CITY OF TULSA
PUBLIC WORKS
Engineering

ADDENDUM NO. 4

ADDENDUM NO. 4
TO
PROJECT NO. 2036W0001Z, 2036A0024Z & TMUA-W 22-37
ARTERIAL STREET RECONSTRUCTION GILCREASE MUSEUM RD. (N. 25th W. AVE.) W. ADMIRAL BLVD. TO W. PINE ST.

ADDENDUM NO. 4
TO
GILCREASE MUSEUM RD.
(N. 25TH W. AVE.)
W. ADMIRAL BLVD TO W. PINE ST.
PROJECT NOS. 2036W001Z, 2036 A0024Z & TMUA-W 22-37

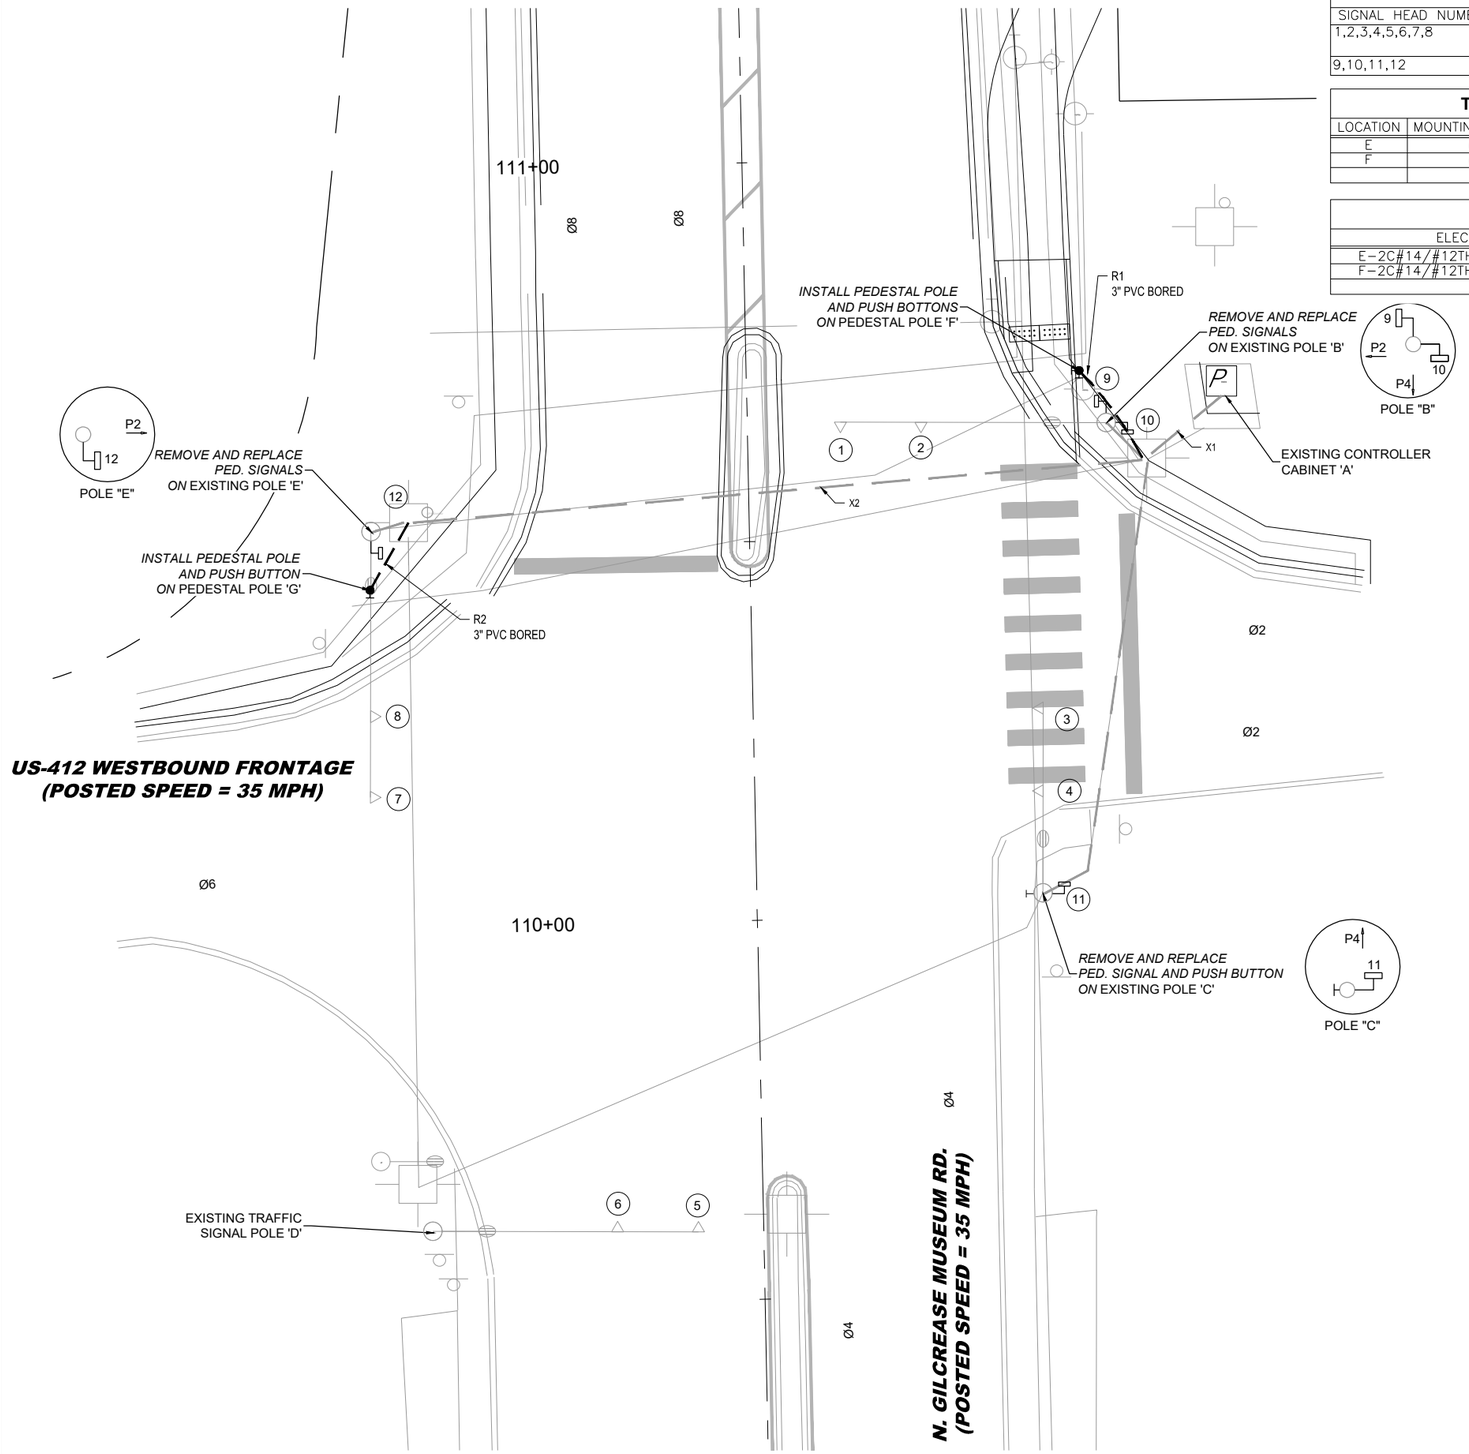
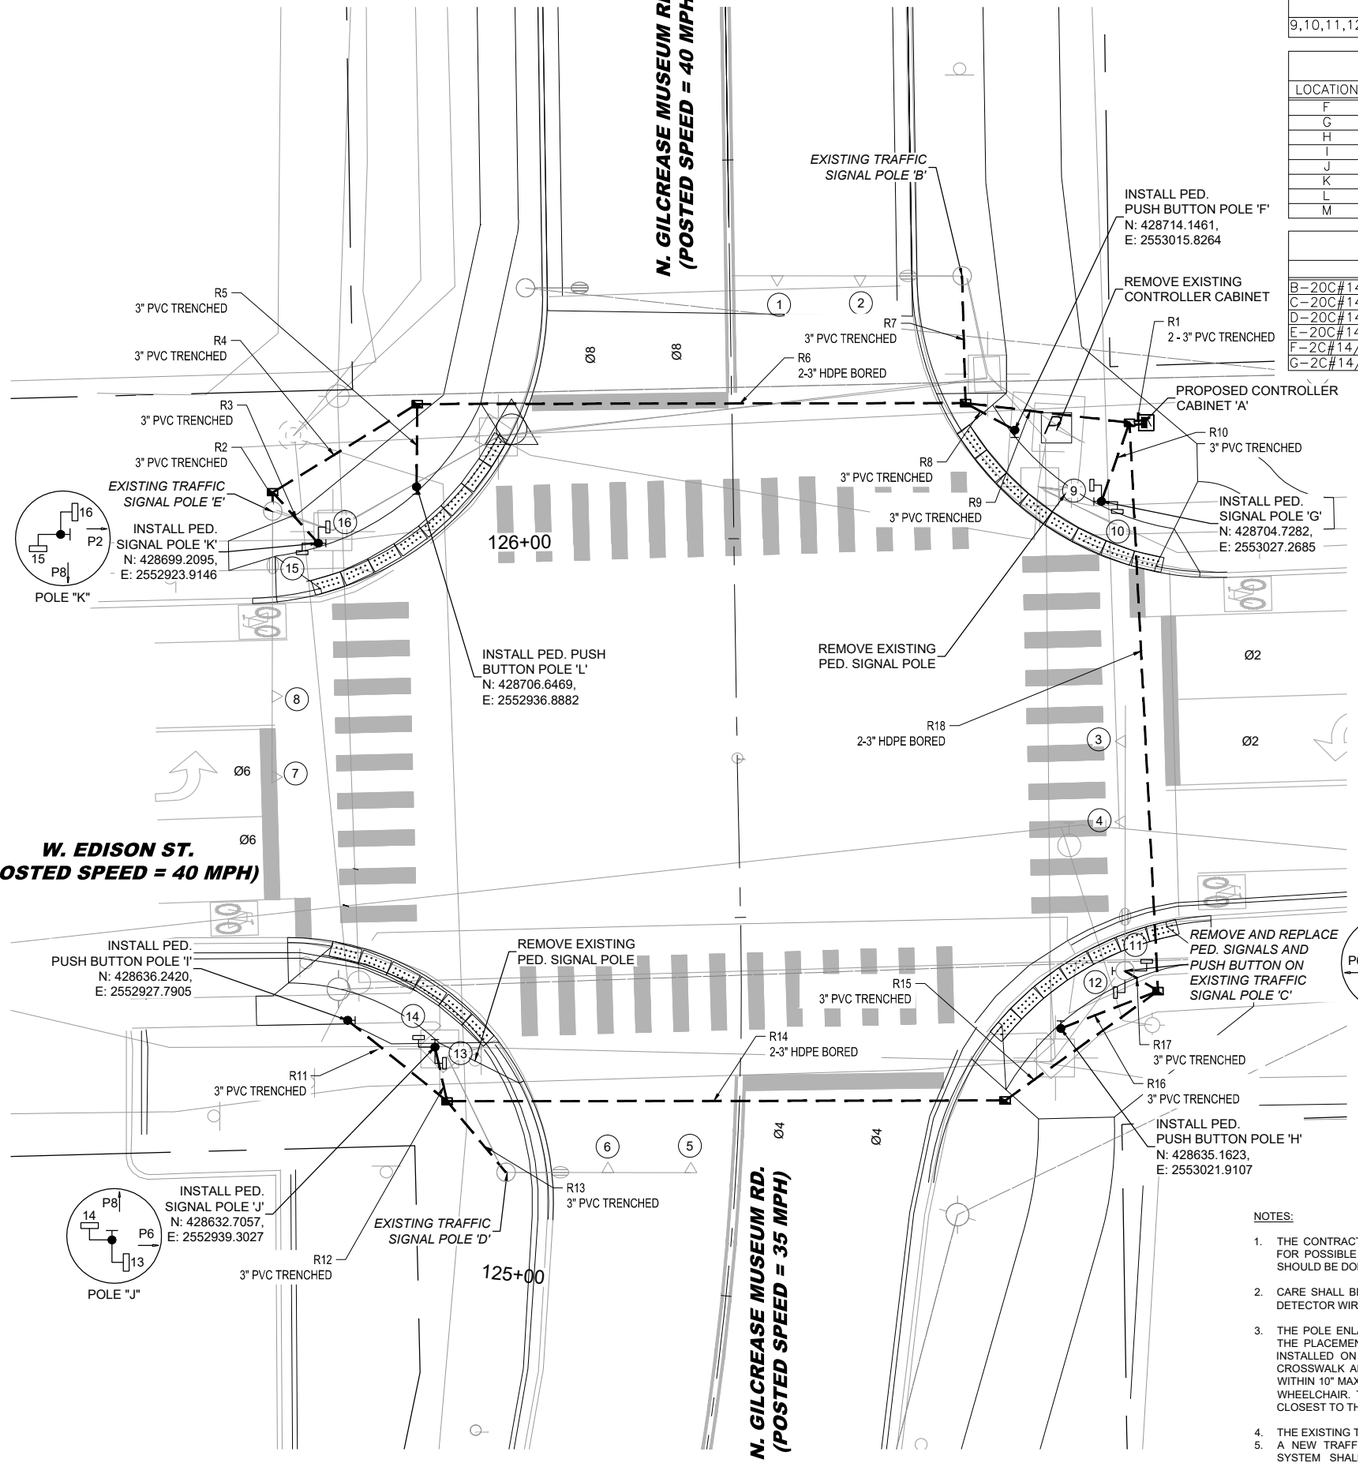
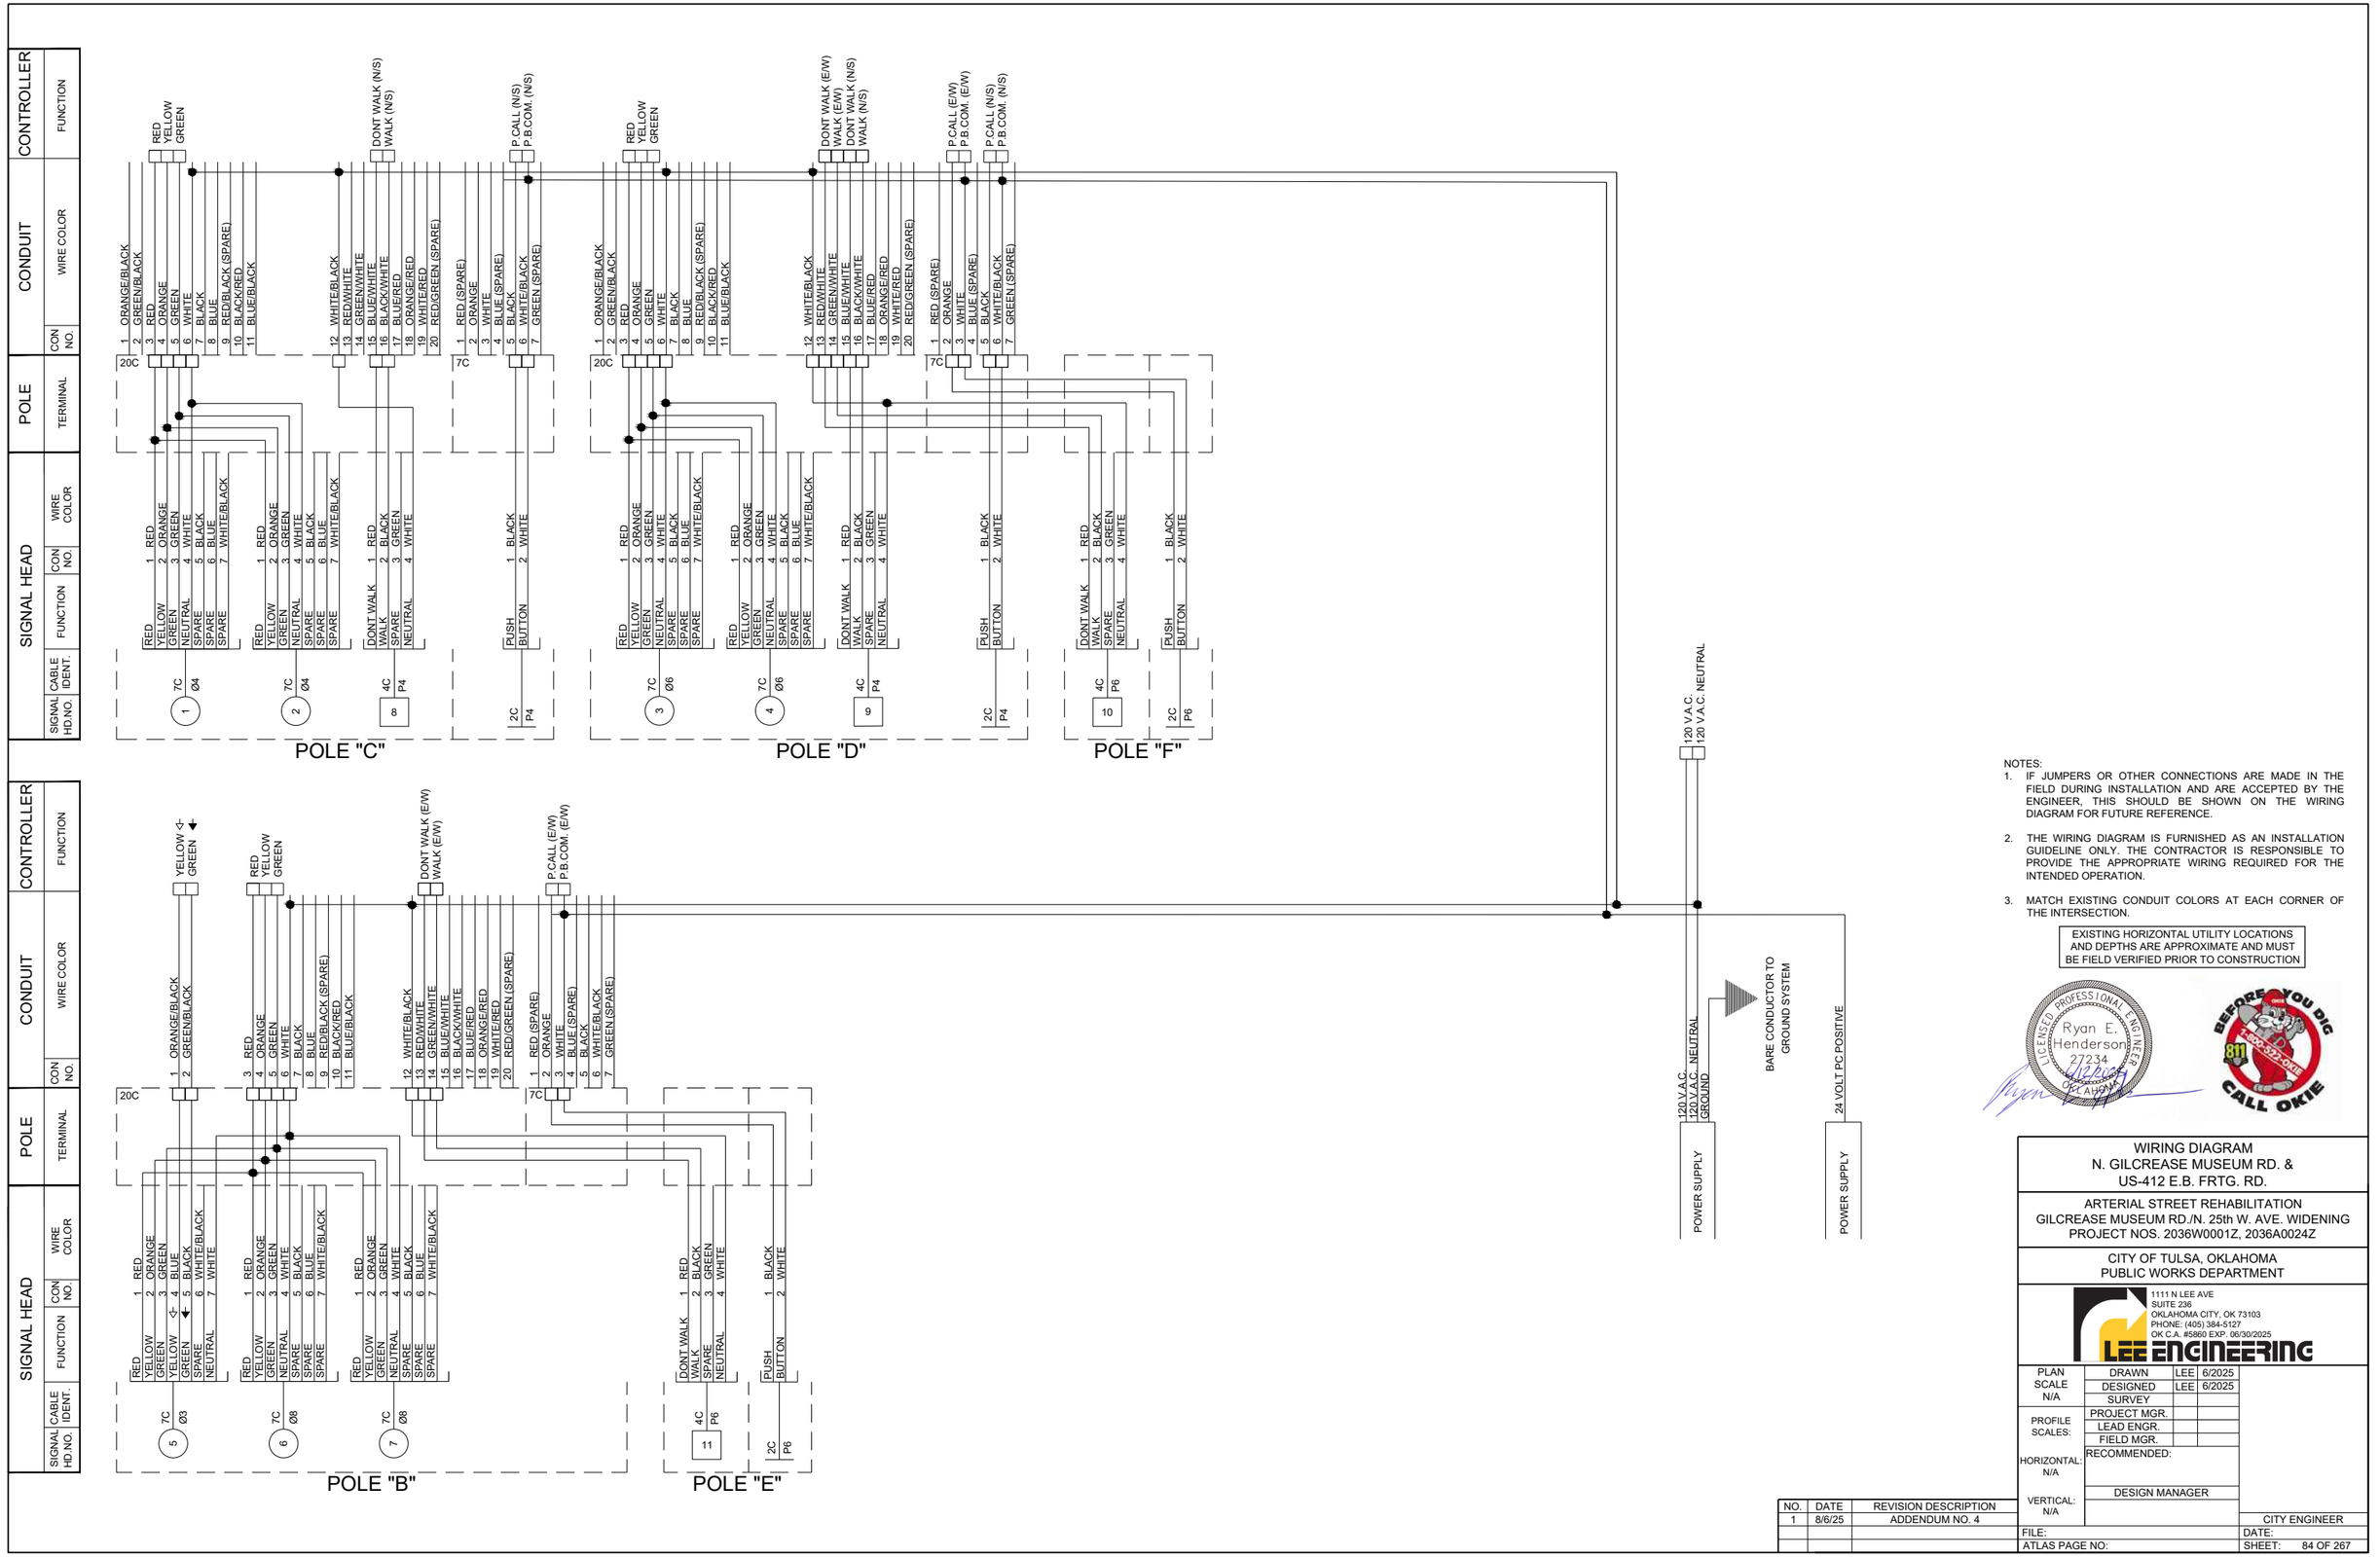
- Added non-pay quantities of concrete and steel used in decorative wall pay item.
- No. S52 with revised Details and Notes.
- Nos. 81 to 86 with revised Signal Designs and Phasing Diagrams.
